有關規劃申請編號：A/YL-SK/393 意見回應。

Filling of Land for Permitted Agricultural Use
at Lots. 459S.B RP, 459 S.B ss.1 & 460 both in D.D. 112
Shui Lau Tin, Pat Heung, N. T.
Reply to A F & C comments

Filling of Land for Permitted Agricultural Use
at Lots 459 S.B ss.1, 459S.S.B RP & 460 both in D.D. 112
Shui Lau Tin, Pat Heung, N. T.
Reply to DSD's comments

Drainage Proposal Submission

車庫出入路線圖

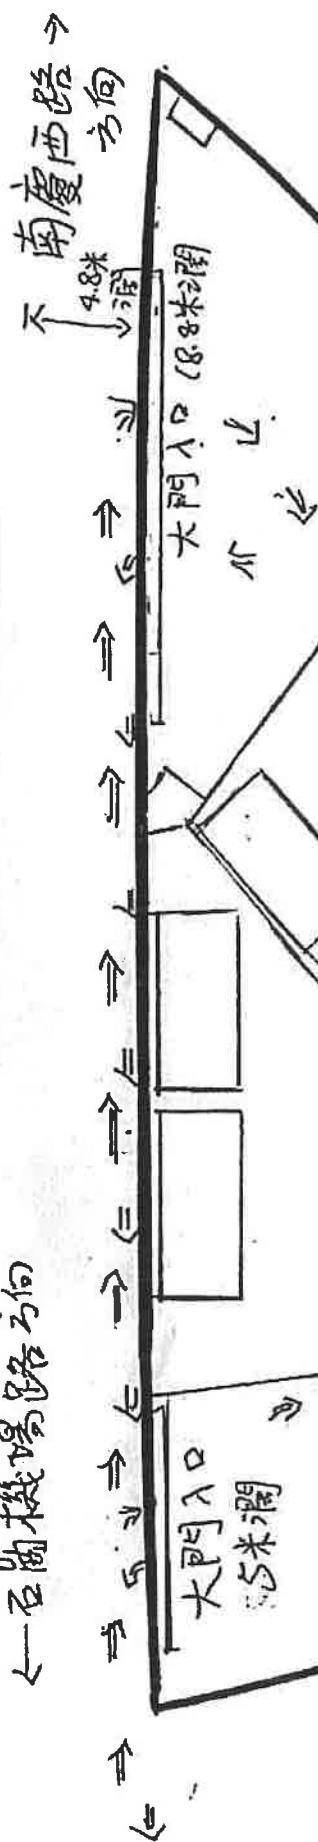
1. 申請人了解石崗松場路有7米車長限制，故申請人只會使用不超過5米長的輕型貨車運送貨物、花苗。
2. 申請人所使用之運送路線，都只會使用石崗松場路來回。且每日出入車只有一至兩次，又在非繁忙時段，故對石崗松場路交通之影響極微。
3. 為釋除疑慮，申請人為地段第460號拍攝了九張圖片，展示輕型貨車由

由石崗私場路駛入,第460號地段5米闊的
大門可以(一手遮天)順利暢駛入,絕不會
做成石崗私場路的阻塞。

布局設計圖

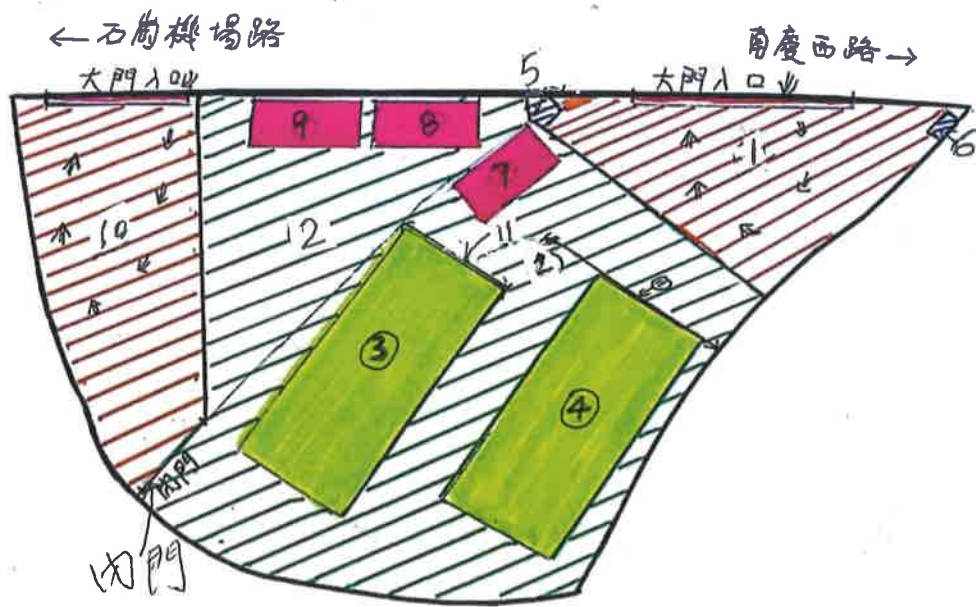
申請人在申請地段進行苗圃工作，有需要平整土地以便放置花盆、花架，及陰棚。部份土地需要鋪設水泥地是方便車輛完全進入苗圃上落貨及掉頭，以免阻礙外圍交通通道。

再者，鋪設水泥地之面積最大為101平方米，總共374.8平方米，對附近環境影響極微。

- (1) 水泥地上落貨區 101 平方米 (沒有固定車位)
 → 輕型貨車, 可於區內掉頭駛出公路, 大門車積長
 方便輕型貨車完全進入及掉頭

- 10 水泥地, 上落貨區 90 米² (沒有固定車位)
 → 輕型貨車可於區內掉頭駛出公路

Proposed Drainage Layout Plan

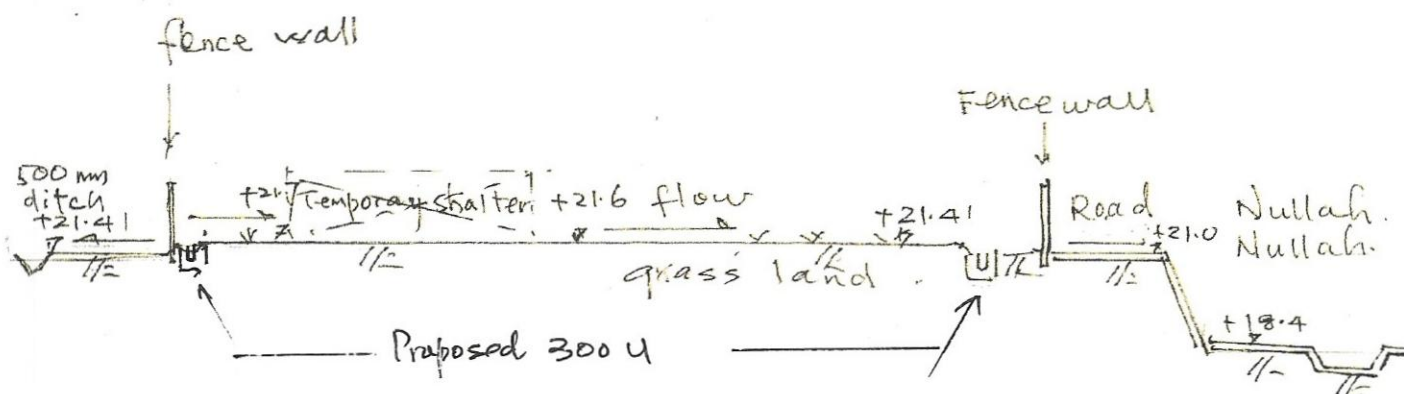
- c) 300 mm peripheral surface channels are provided for the proposed site. As calculated, the capacity is 900 % more than required.
- d) Noted. We will provide adequate opening to the fence wall for intercepting of the overland flow passing through the site.

- e) We confirm that the total catchment area of the two drainage system is 540 m³, sum of 270 m³ and 270 m³.
- f) Noted. We will resolve any conflict/disagreement with relevant lot owners and seek LandsD's permission for laying new drains/channels and /or modifying/upgrading existing ones in other private lots or on Government land outside the application site.

As indicated in the drainage layout plan in appendix IV, all the surface water induced in the site area and adjacent areas are discharged into the proposed 300mm U-channel along the perimeter inside the lot fence wall, then is discharged through the proposed 300mm diameter uPVC drainpipe, then further discharged to further downstream, the 7.0 meters nullah.

Adequate opening, 75mm diameter @1.0 meter C/C at the fence wall will be formed for intercepting of the overland flow passing through the site.
